**ADDENDUM 01**

Addendum #	01	Date Issued	03/21/2025
Project Name Job #	SWN 0509, Waneta Hall Renovate Restrooms	OSE #	R0325--15X
		EAPC #	20256780
Bid Date Time	April 3, 2025		3:30pm

PROJECT DESCRIPTION
SWN 0509, WANETA HALL RENOVATE RESTROOMS (OSE# R0325--15X)

2 REFLECTED CEILING PLAN - MEN FIRST FLOOR
A301 1/4" = 1'-0"

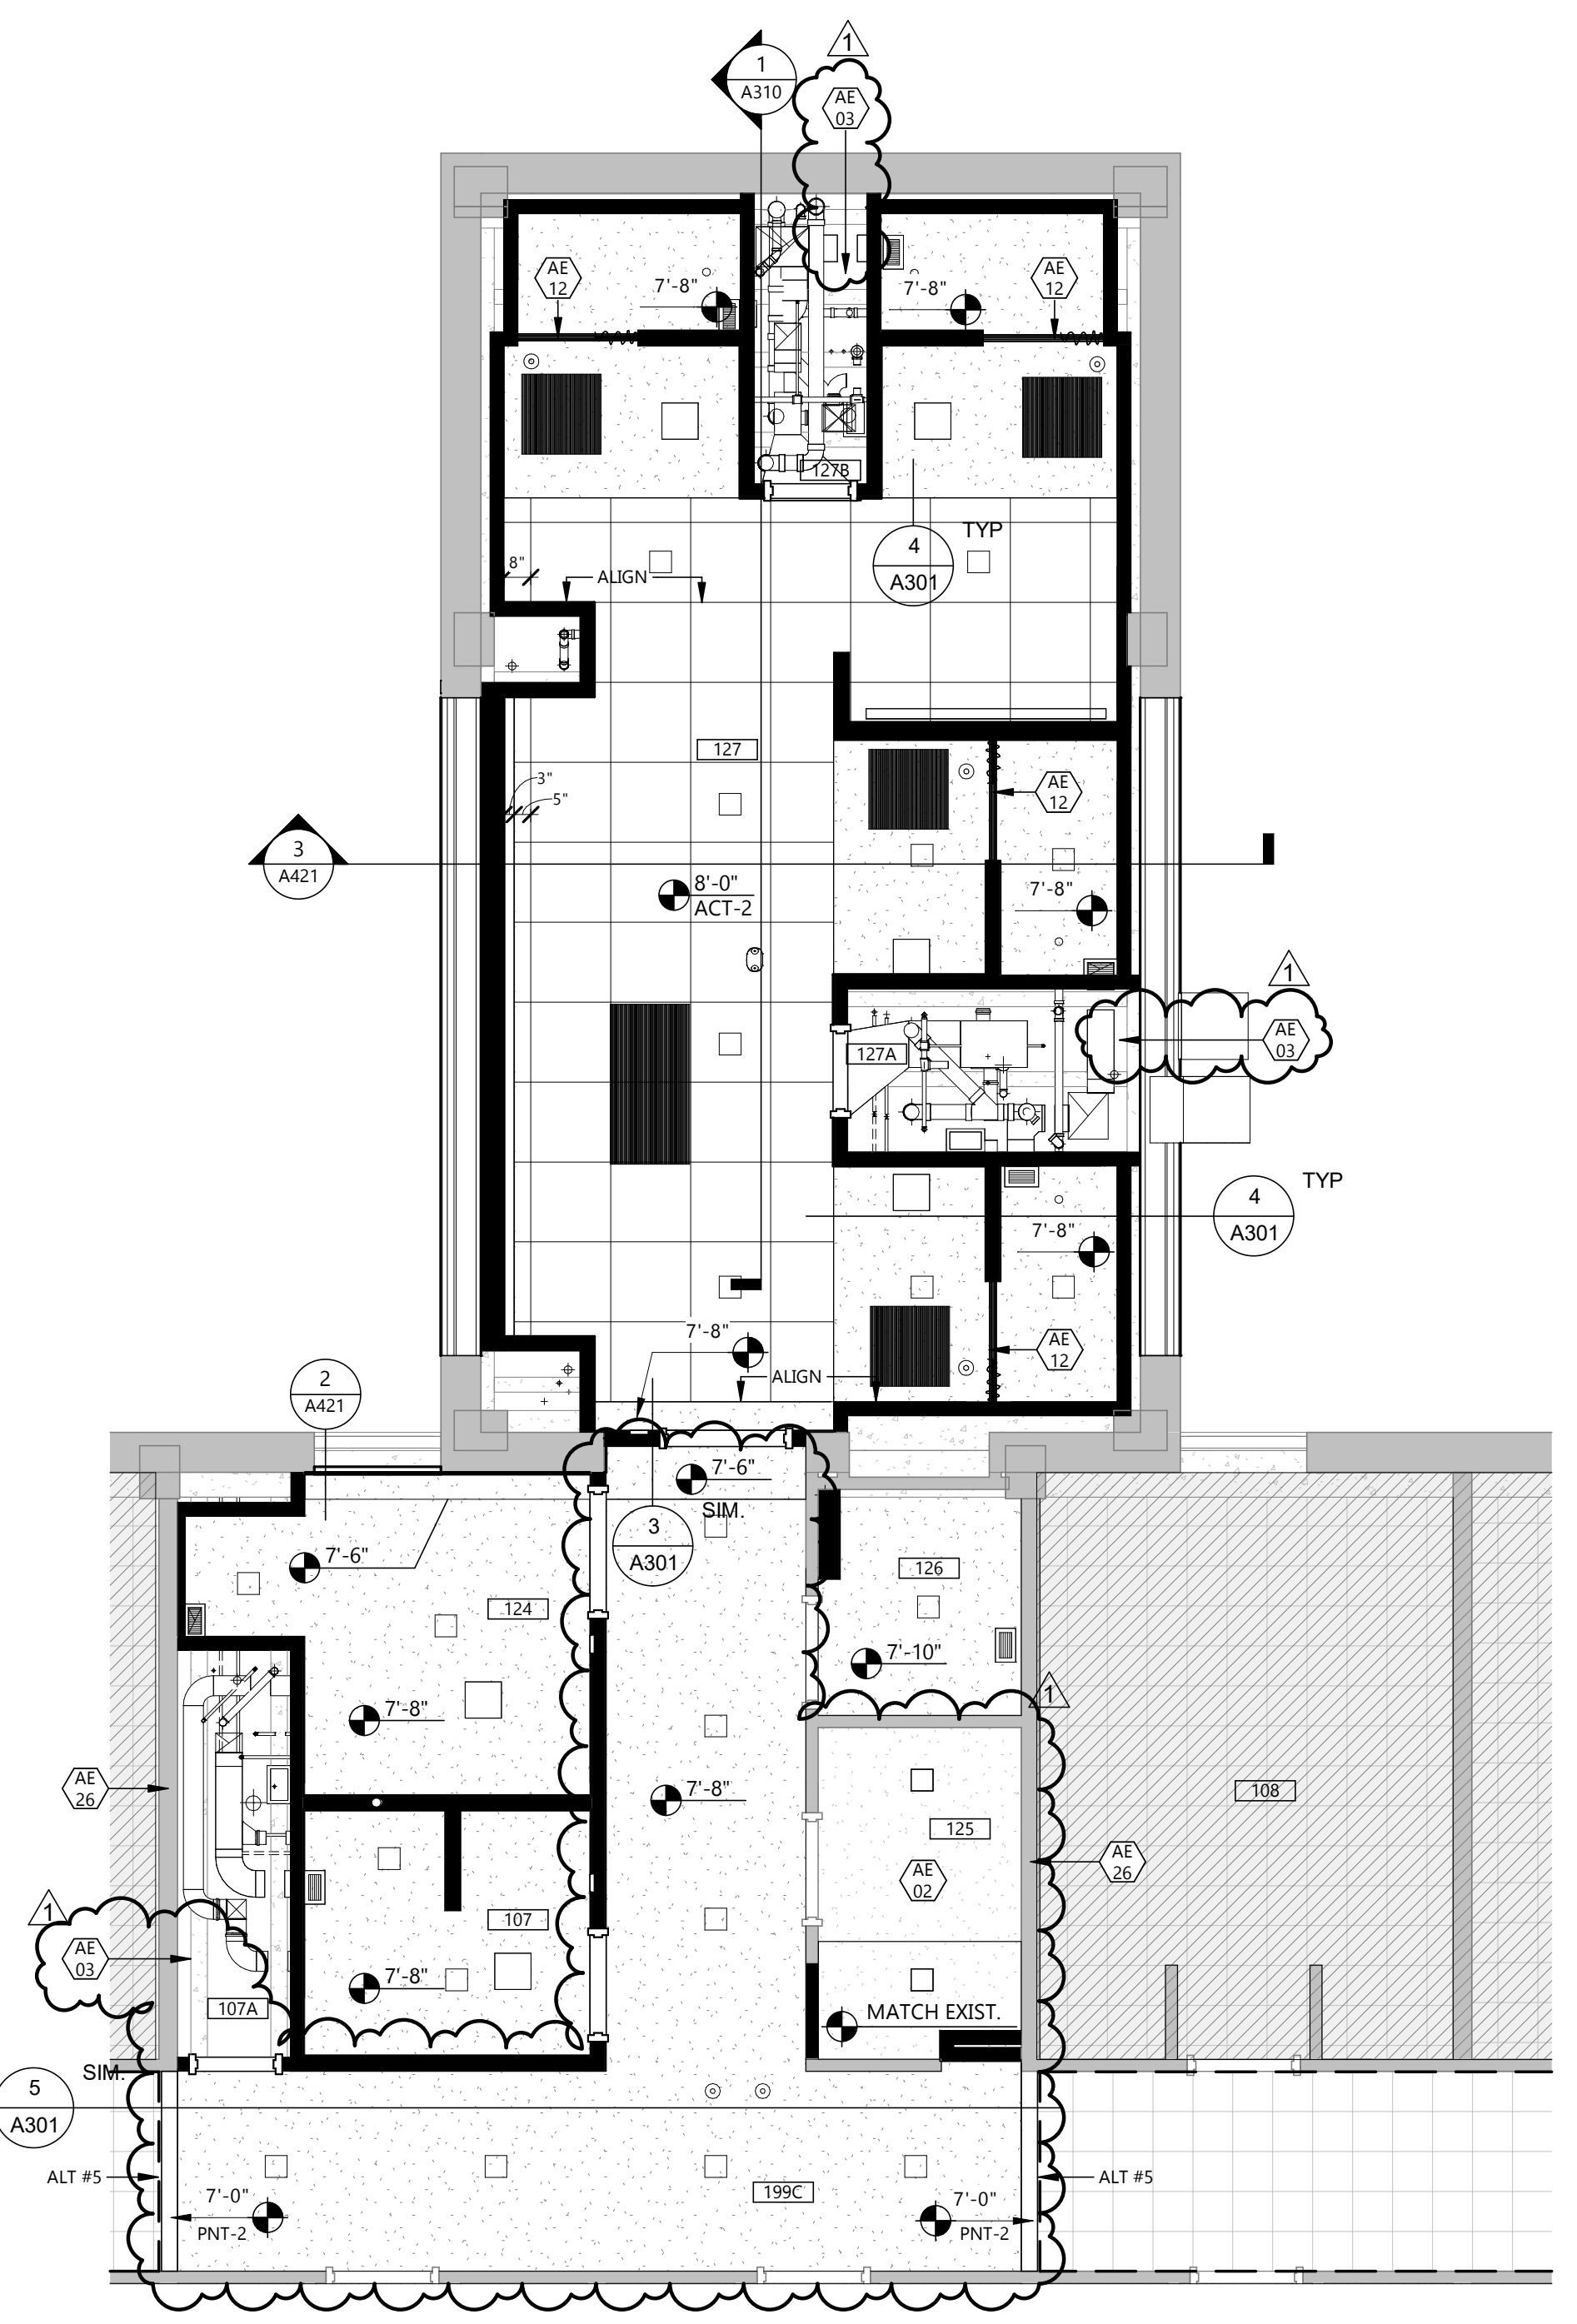
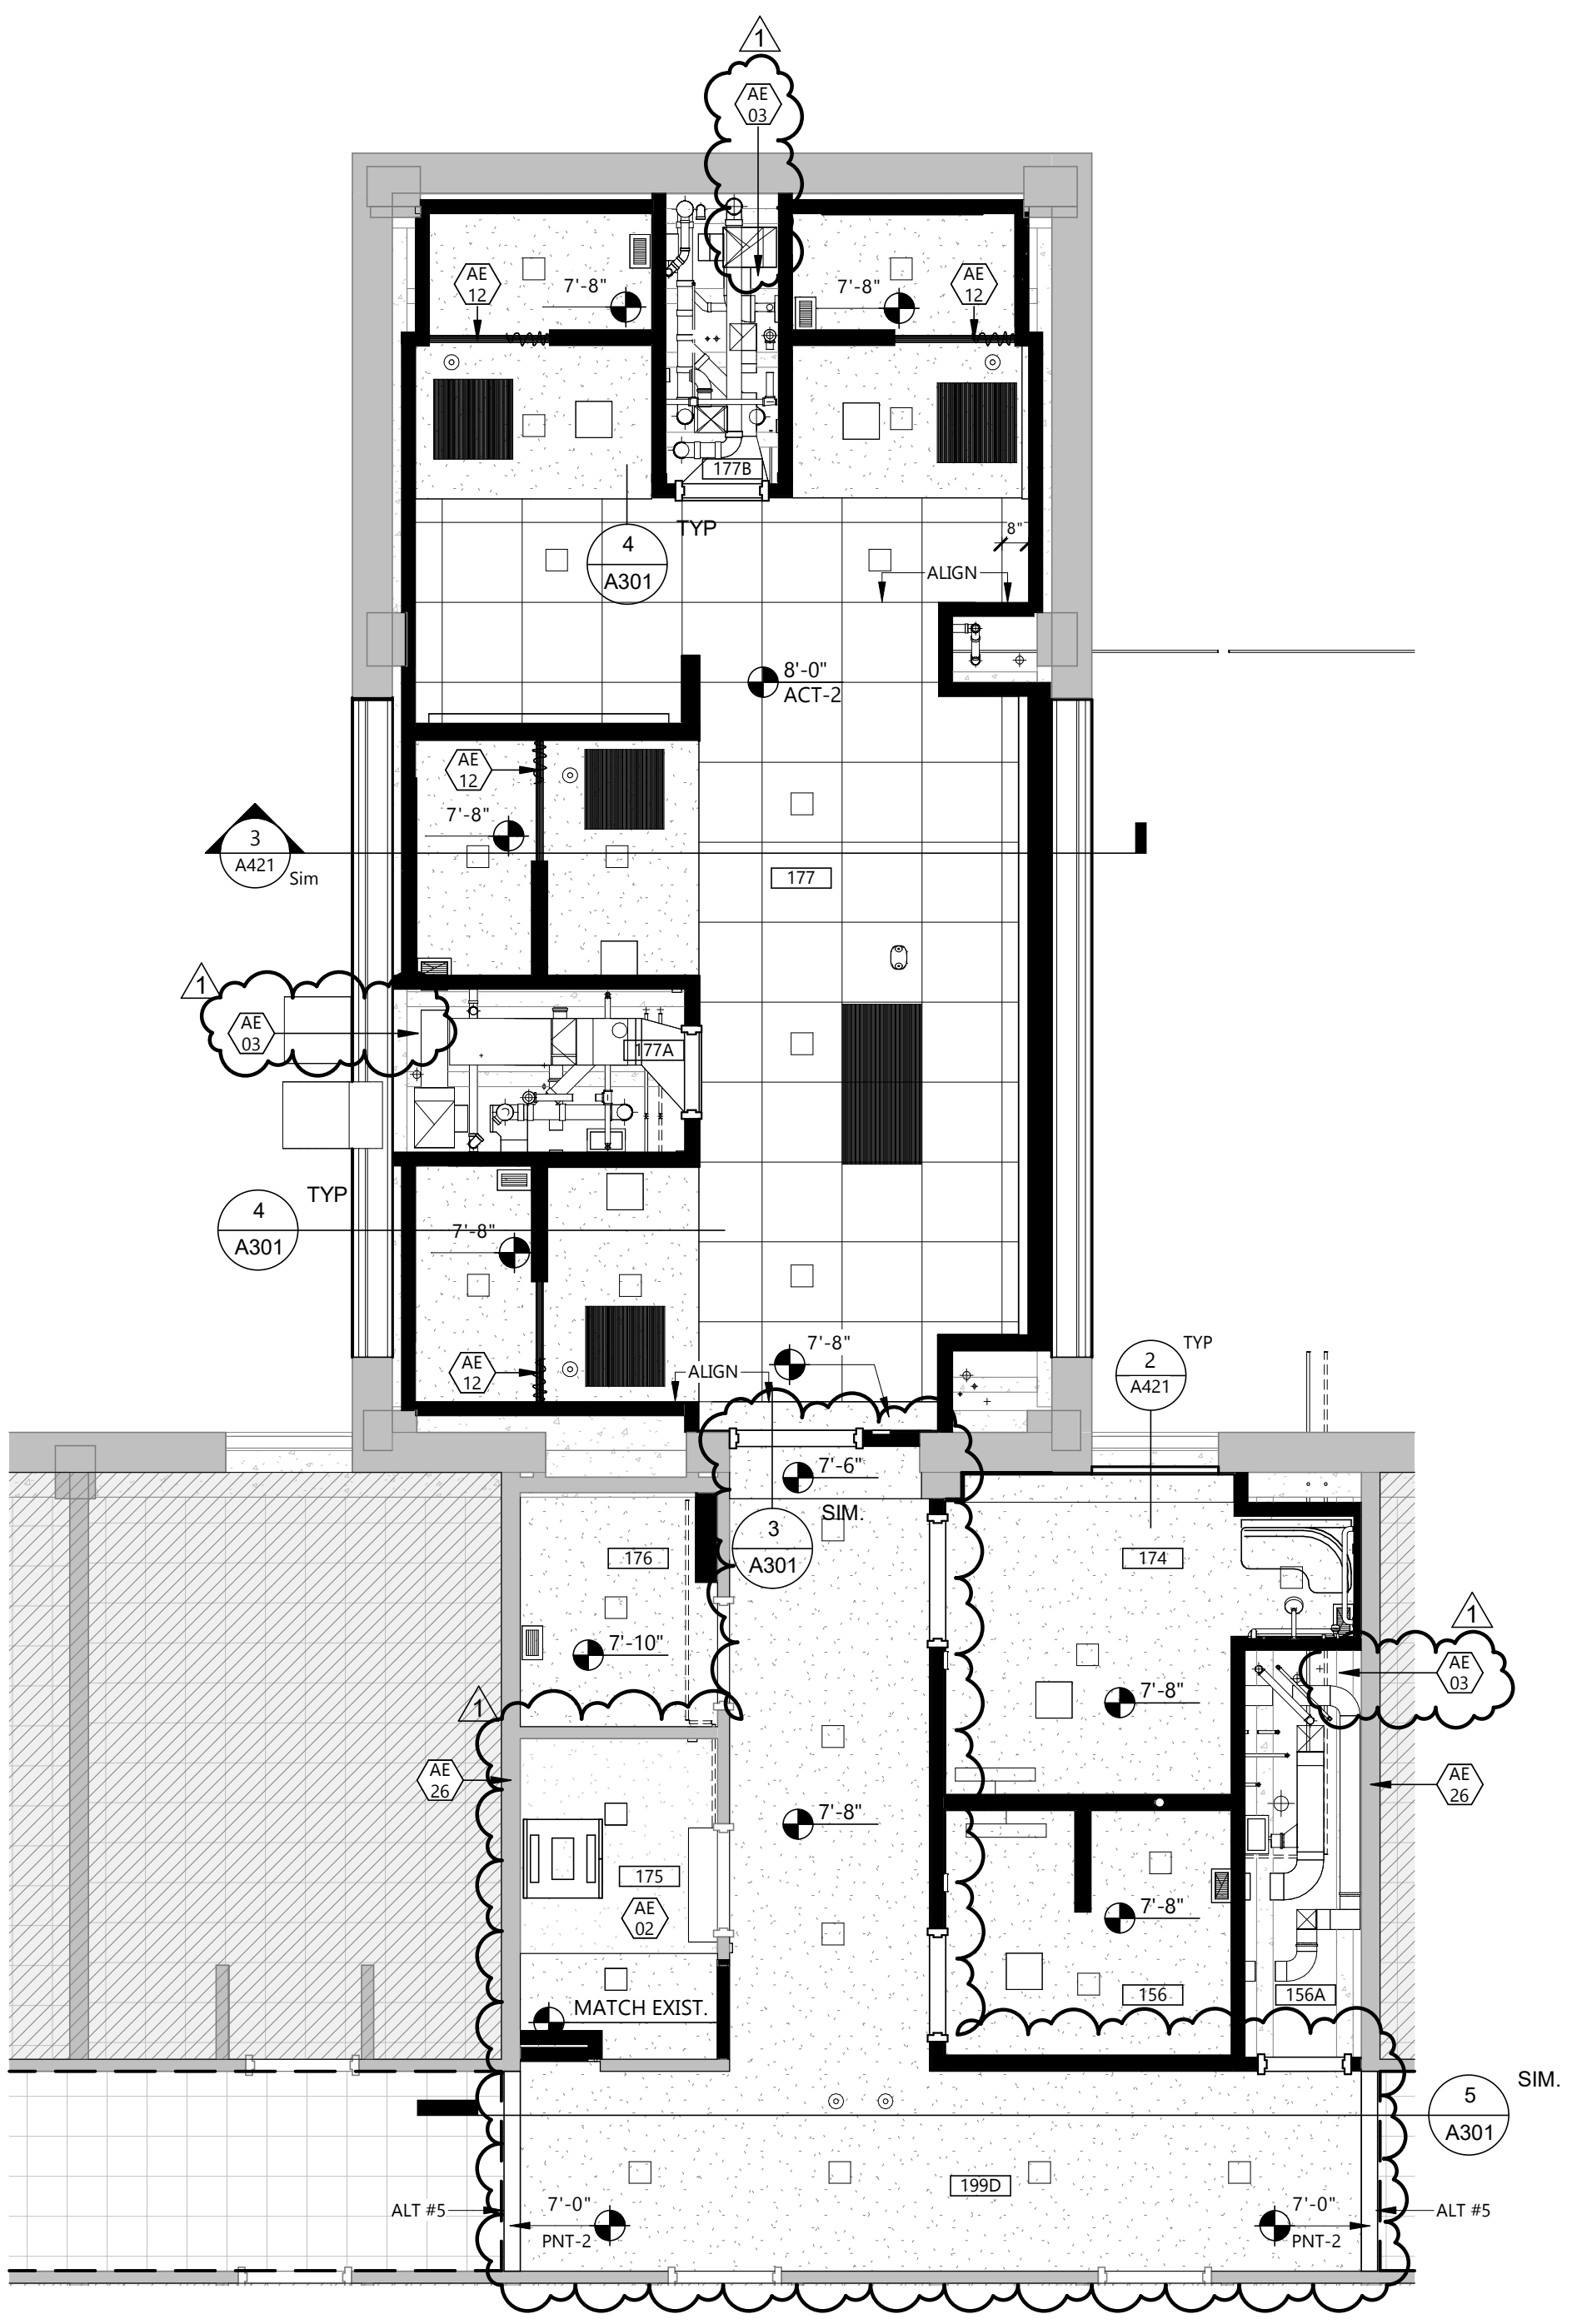
A101	REVISE extents of concrete demolition. REVISE Keynote AD 10.
A200	ADD Keynote AE 35.
A201	REVISE extents of concrete pad. REVISE Keynotes AE 35 & AE 52.
A301	REVISE Issue Date. REVISE General Ceiling Note #6. ADD Keynotes AE 02 and AE 03. Revise ceiling and lighting layouts in rooms 125, 175 and the hallways around the new construction.
A302	REVISE General Ceiling Note #6. ADD Keynote AE 03. Revise lighting layouts in the hallways around the new construction. ADD notes for extents of Alt. #5 on 1/A302.
A303	REVISE General Ceiling Note #6. ADD Keynote AE 03. Revise lighting layouts in the hallways around the new construction.
A304	REVISE issue date. REVISE lighting layout on at the student space 102. Extend wall in Kitchen 130 to ceiling.

6. WHERE CEILINGS ARE INDICATED TO BE EXPOSED TO STRUCTURE, PAINT ALL UNFINISHED MATERIALS OVERHEAD UNO, INCLUDING, BUT NOT LIMITED TO: ROOF DECKING, JOISTS, DUCTS, PIPING, CONDUIT, ETC. SEE FINISHES SHEET FOR PAINT.
